AS4407™

RATIONALE

FITTING ASSEMBLY, ELBOW 90°,
REDUCER AND NONREDUCER,
INTERNAL FLARE TO FLARED TUBE

ISSUED 1995-03 REAFFIRMED 2007-10 REVISED 2023-06

FIGURE 1 - FITTING ASSEMBLY, ELBOW 90°

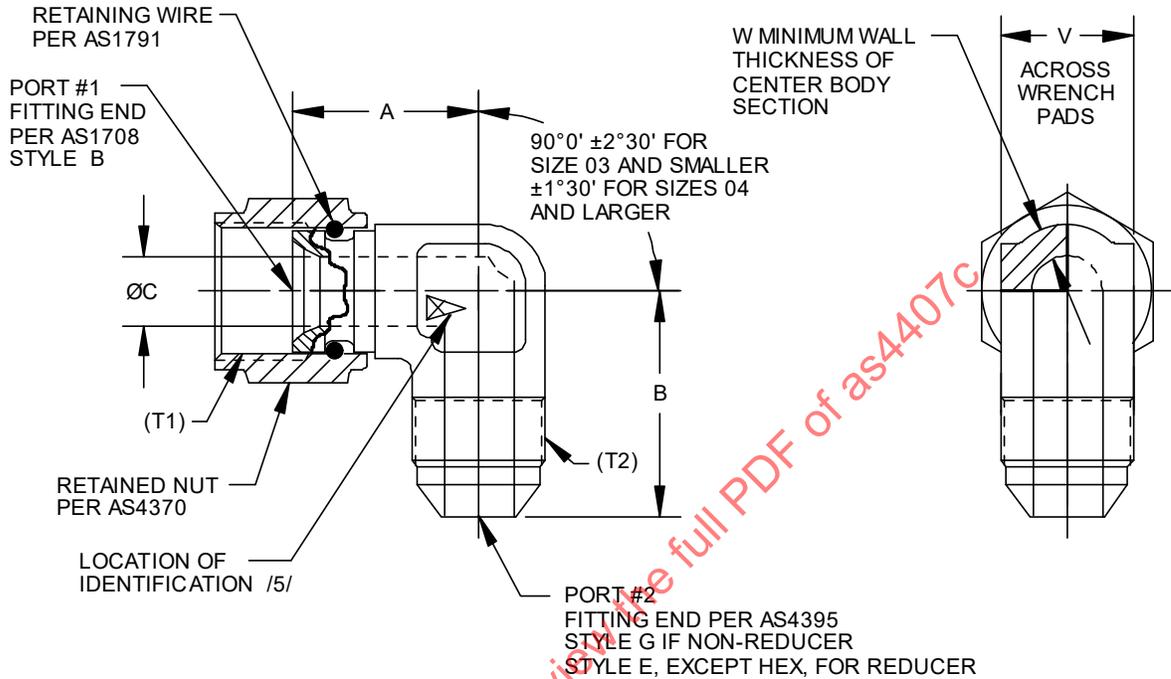
WRENCH PAD DIMENSION V RELOCATED TO ACTUAL PAD FEATURE. CLASSES 3A AND 3B ADDED TO TABLE 1 HEADING FOR THE THREADS. MATERIAL CODE LETTER R, CRES 321, INTRODUCED AS AN OPTIONAL MATERIAL. FINISH FOR MATERIAL CODE LETTER R BEING INTRODUCED. REFERENCE TO VAD REMOVED FROM PROCUREMENT SPECIFICATION NOTE. UPDATED SPECIFICATION CALLOUT FROM MIL-A-8625 TO MIL-PRF-8625. NOTE /17/ REVISED TO REFLECT OPTIONAL DRY FILM CODE LETTER N CALLOUT FOR SWIVEL NUT. RECOMMENDATION USAGE NOTE FOR ALUMINUM IN NOTE /18/ REVISED. NEW USAGE RECOMMENDATION FOR MATERIAL 347 ADDED TO NOTE /18/.
